ADDENDUM

Project Name:	Kosciuszko Middle School Toilet Room Upgrades	Addendum No:	One (1)
Project Number:	16-118	Issue Date:	April 29, 2016
Project Location:	Hamtramck, Michigan

To the Contract Documents for the requested Kosciuszko Middle School Toilet Room Upgrades

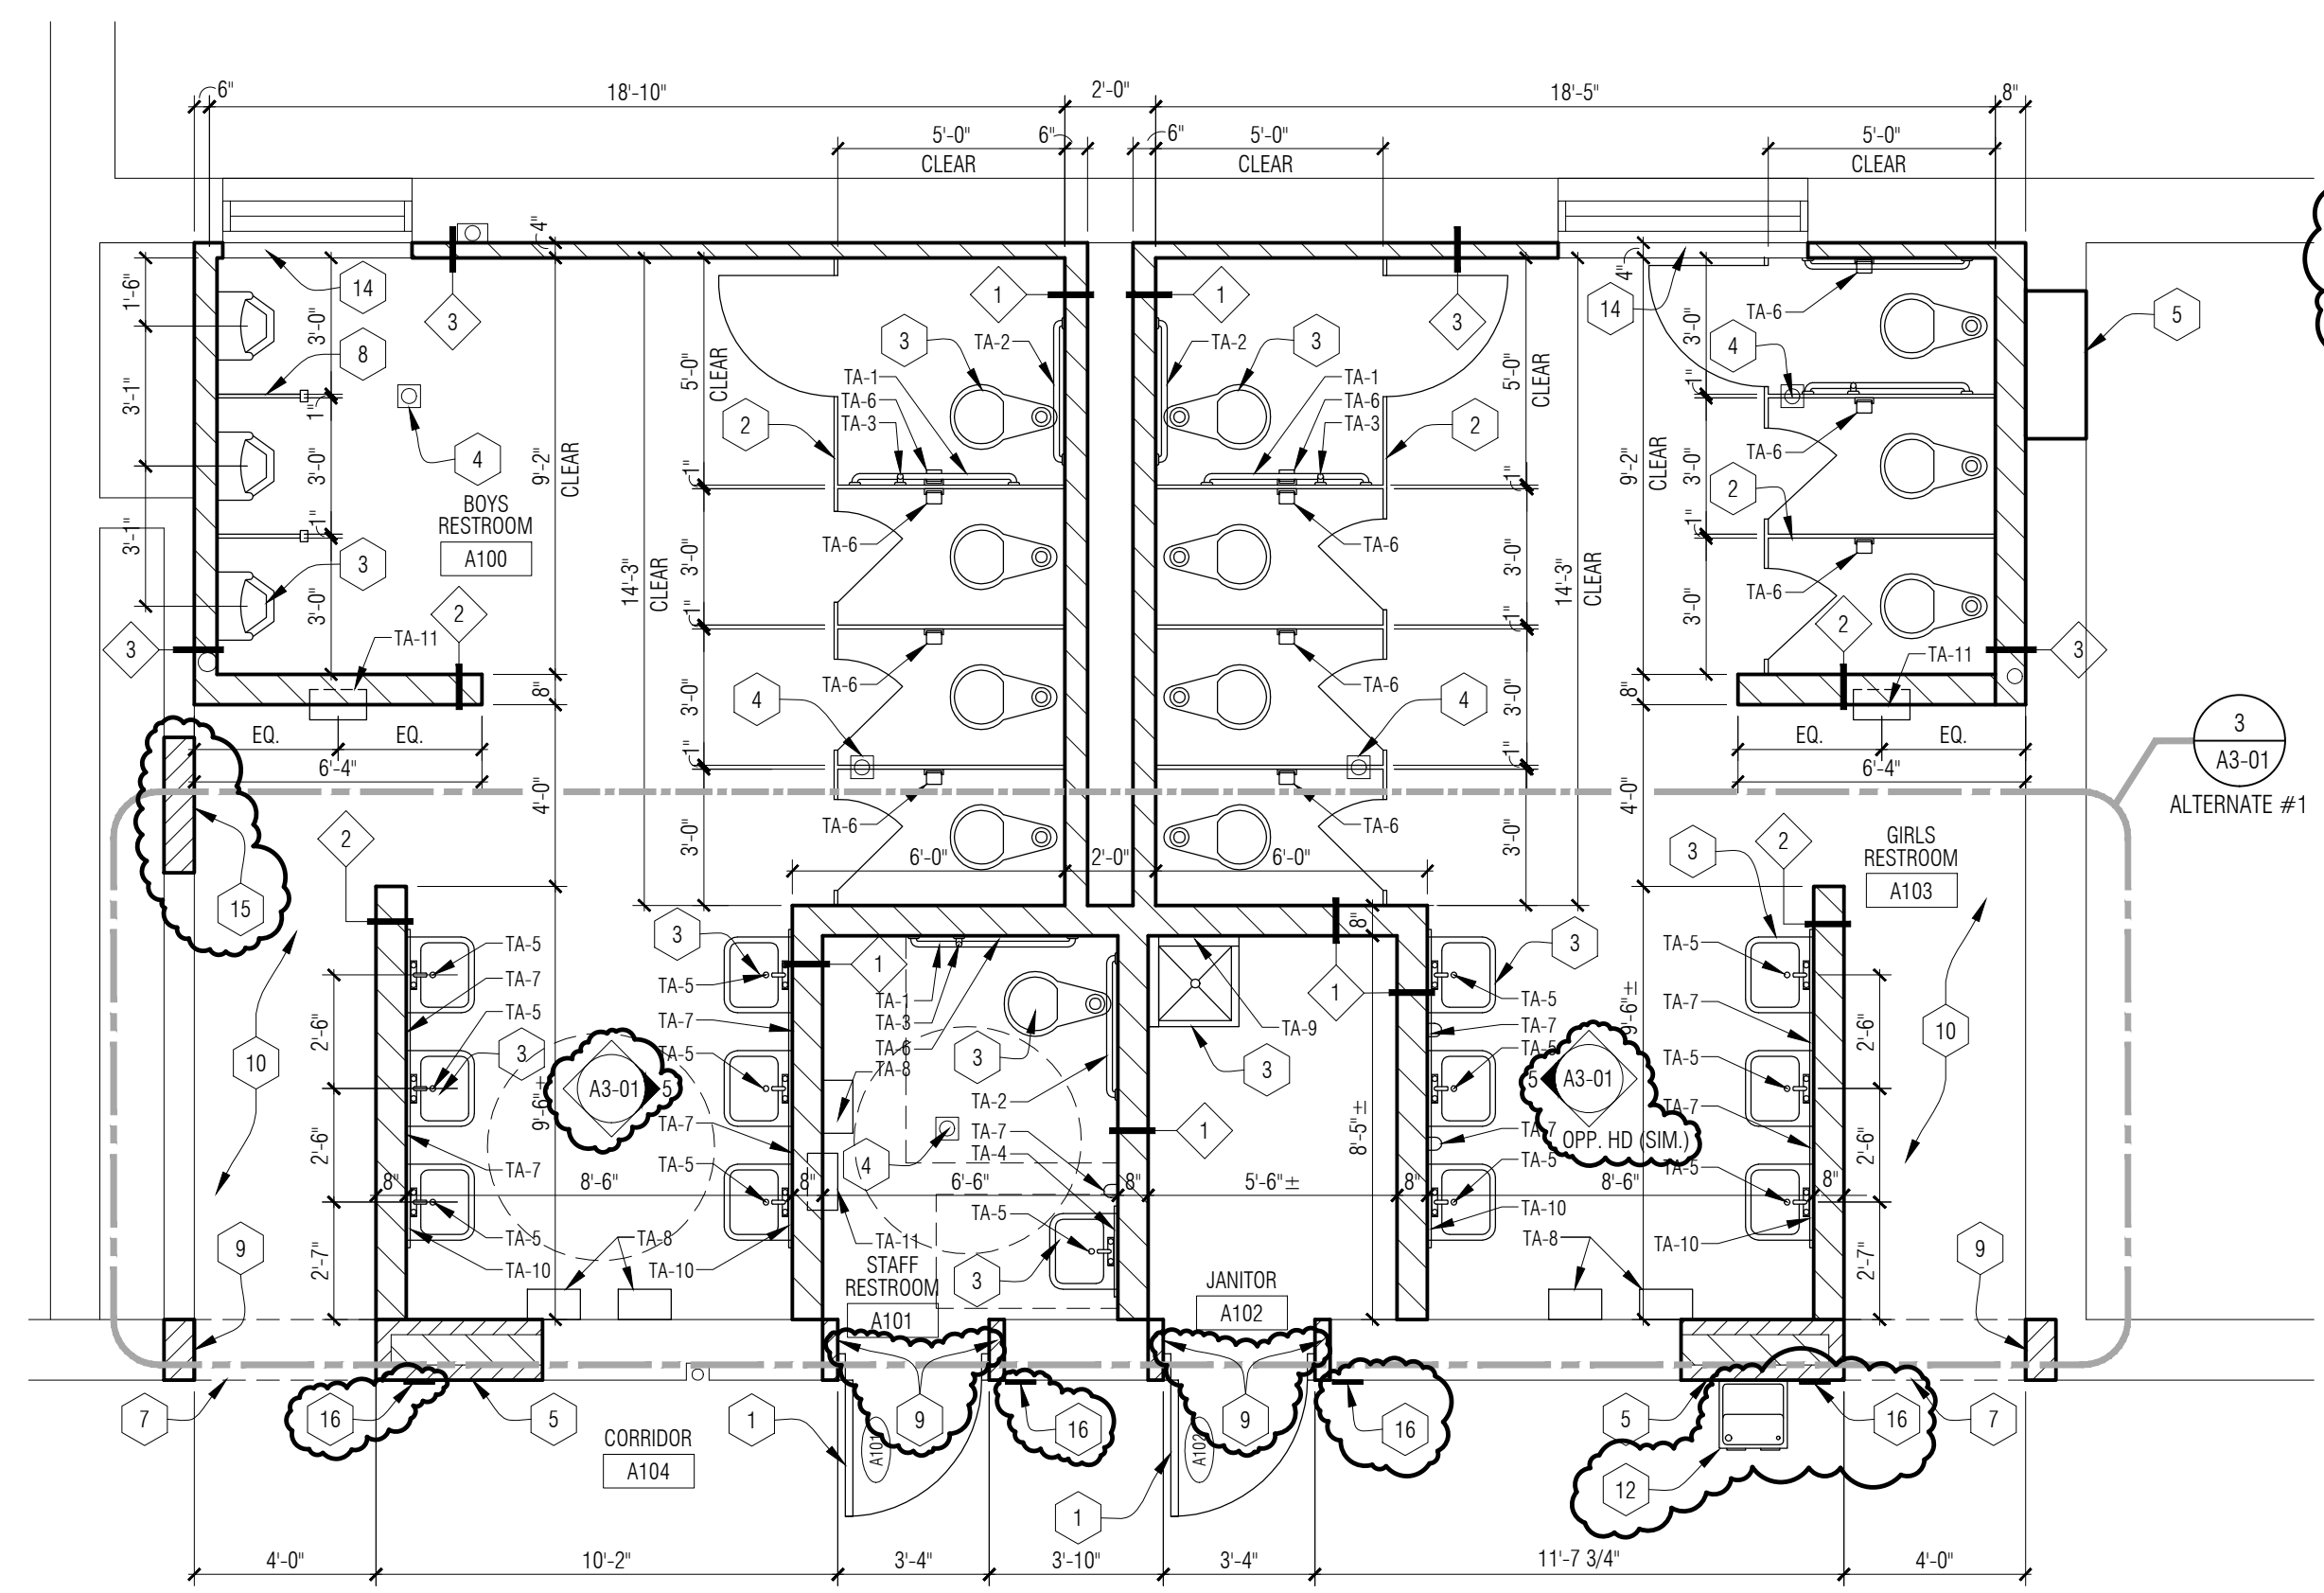
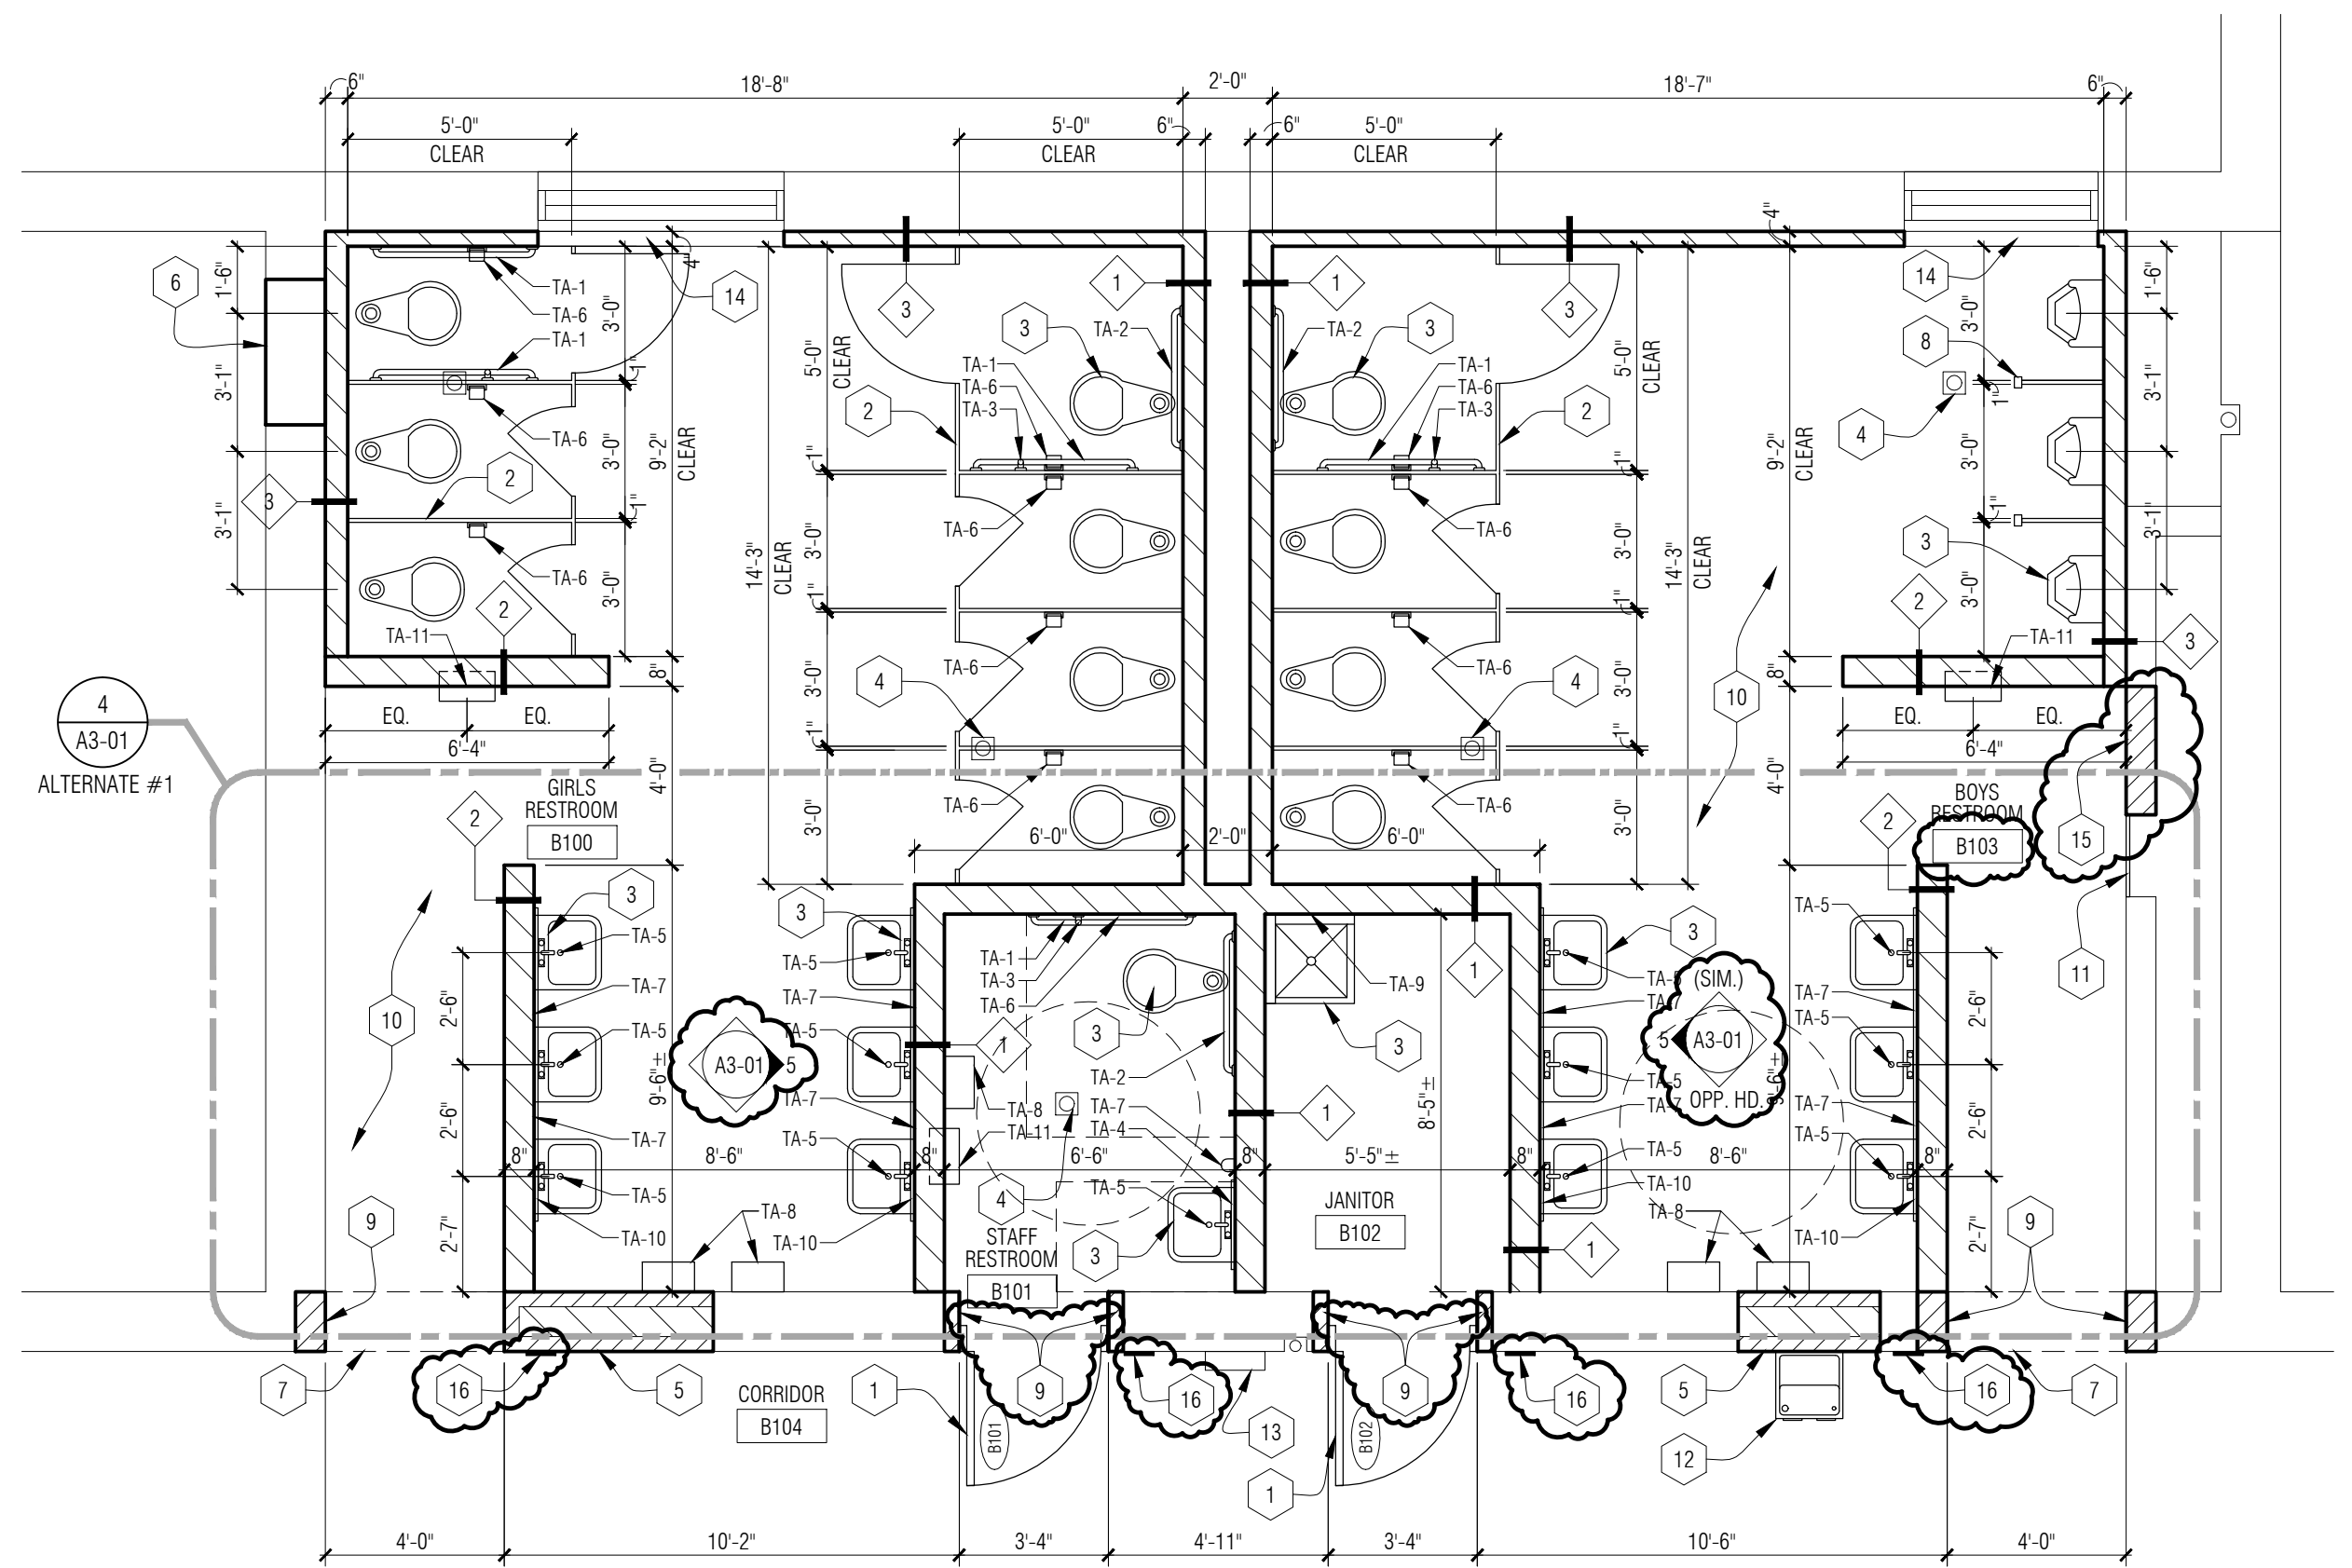
Item A1 Drawing A0-04; Schedules, Door, Frame and Wall Types (revised and reissued this Addendum)
A. Revised Room Finish Schedule as indicated
B. Added signage schedule and details
